**SINGAPORE CIVIL DEFENCE FORCE**

**Our Ref:** CD/04/05/01/01

**Date** : 2 Sep 2024

## **AMENDMENTS TO FIRE CODE 2023 – 2<sup>nd</sup> BATCH OF AMENDMENTS**

Diagram 4.2.2i.(3): Pictogram signage for fire engine accessway/ fire engine access road

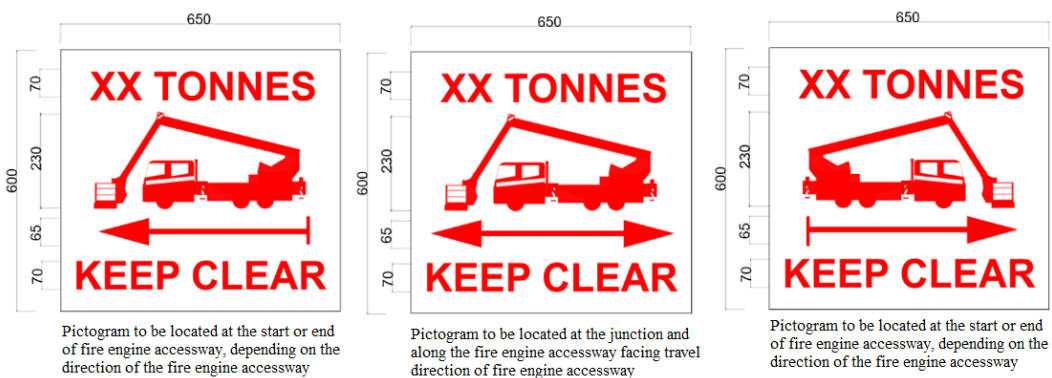
**Pictogram of fire engine access road for firefighting appliance equal or more than 24 tonnes but less than 30 tonnes**

**Pictogram of fire engine access road for firefighting appliance equal or more than 30 tonnes**

**Pictogram of fire engine accessway appliance for firefighting appliance equal or more than 30 tonnes**
